**Draft Darebin Planning Scheme Amendment C182dare
Referral 7 – Preston Market Precinct Structure Plan**

VPA Projects Standing Advisory Committee Report

16 December 2022

Figure 17 PSP Land use and Activation Plan

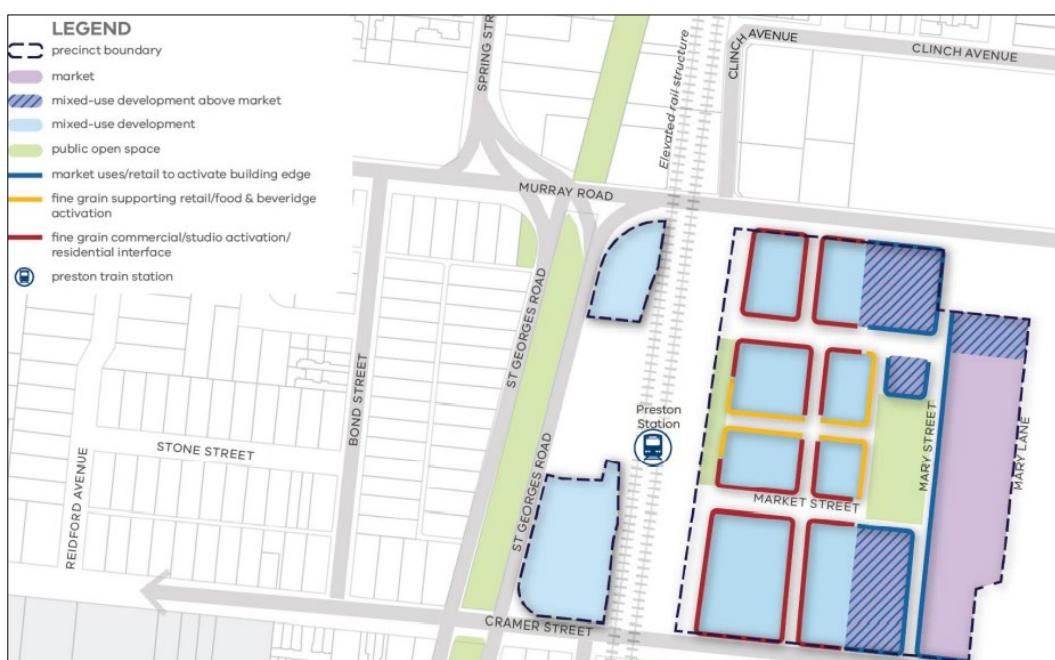
The Land Use and Activation Plan in the PSP (Figure 17) depicts an outcome where most internal streets are shown with ground floor activation and preferred street wall heights. Mary Lane is in essence, the 'back' or service vehicle access to the market and the High Street shops. The plan provides a hierarchy of interfaces and 'backs' and 'fronts'.

Figure 24 Extent of Overshadowing as proposed by PMD in closing with Committee's recommendation

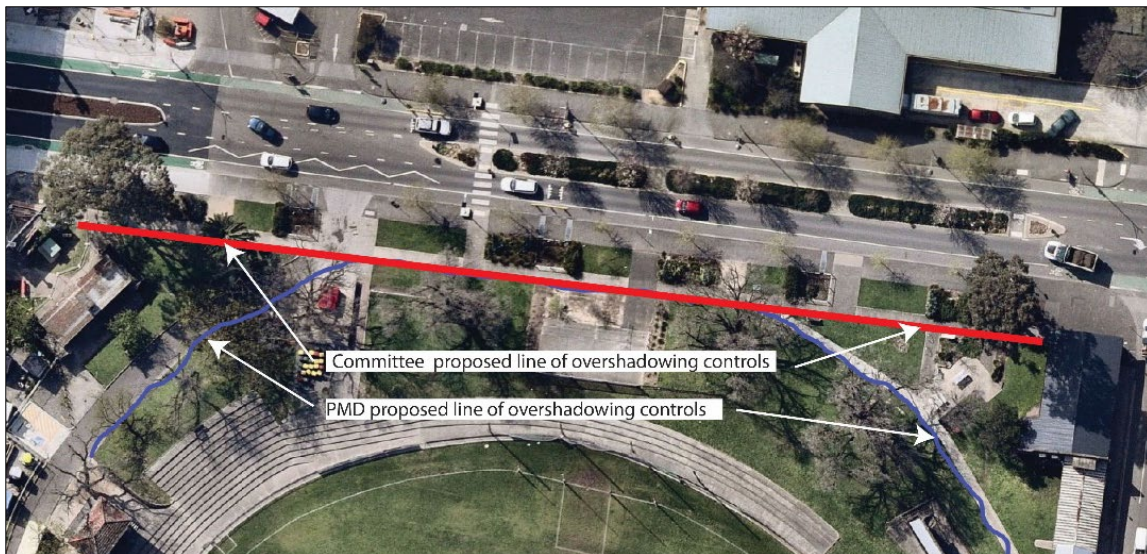
The Committee agrees with the need to protect the public open space north of the Preston City Oval playing surface, however it is satisfied that there is scope to limit the overshadowing controls to all areas south of the inner footpath in an effort to find balance between quality public realm and urban consolidation. This view is partially in line with the recommendation from PMD in closing, however the Committee considers the area to be protected must include the picnic and bbq facilities (refer Figure 24 with Committee's shadowing edge shown in red).

- An additional requirement for the areas of the public open space north of the Preston City Oval playing surface to the southern edge of the inner footpath and south side of Cramer Street (including the bbq/picnic area in the north-eastern corner) not be overshadowed on the winter solstice between 11am and 2pm should be included as identified in Figure 24.

Figure 28 Proposed realignment of Murray Road/Clinch Avenue intersection

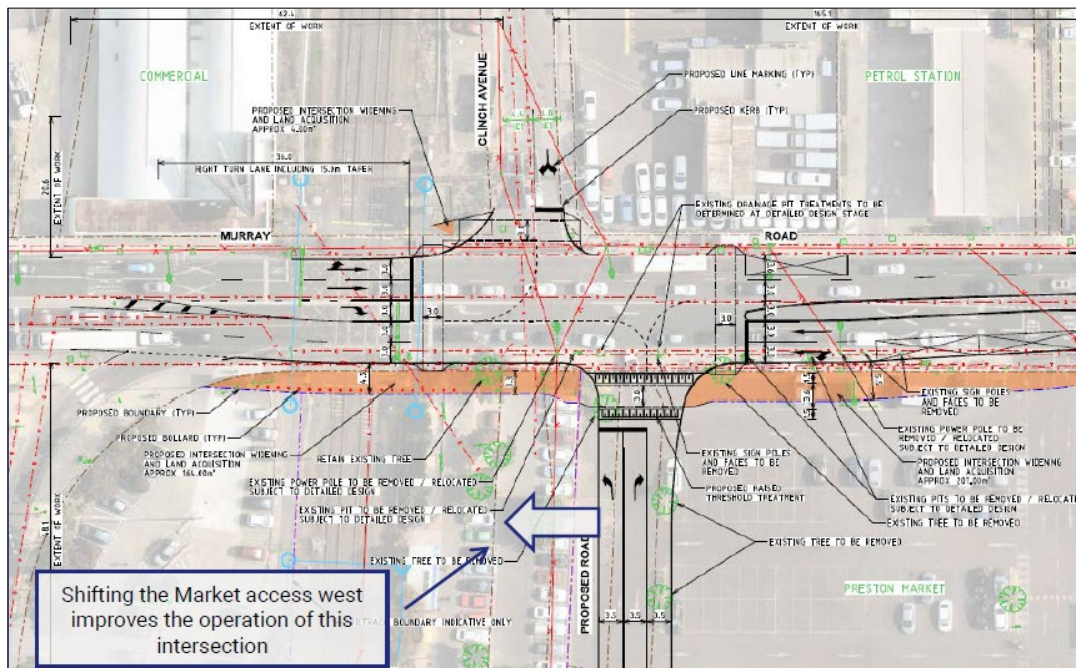
Mr De Young's evidence identified two significant modifications which would further improve the performance of the surrounding road network which were supported by the conclave experts:

- Cramer Street/South West Intersection (IN-04) – replace shared left/right exit lane with separate left and right turn lanes
- Murray Road/Clinch Avenue/North East intersection (IN-02) – shift internal road further west to improve its functionality and capacity (Figure 28) which would require utilising VicTrack land but improve connectivity of the shared path alignment and potentially provide additional separate left and right turn lanes on the internal road.

Plan 1: Mandatory maximum street wall heights and preferred maximum building heights and discretionary upper level setbacks

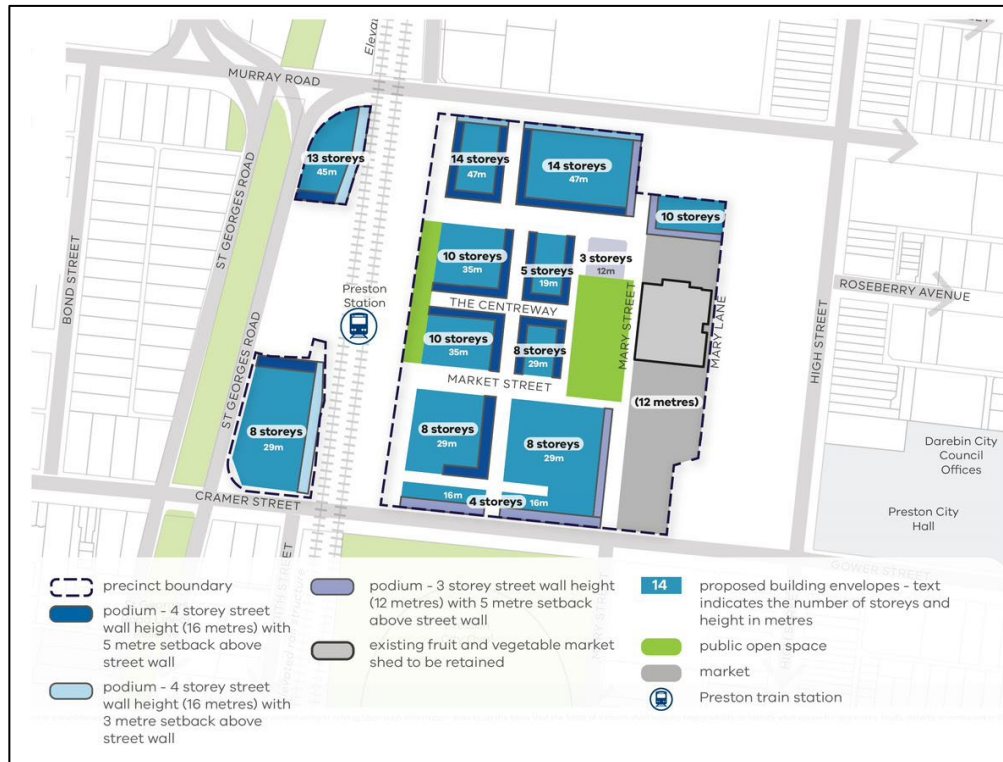
Committee note: Replace Plan 1 with an amended Plan that provides for a retained market and amended urban structure
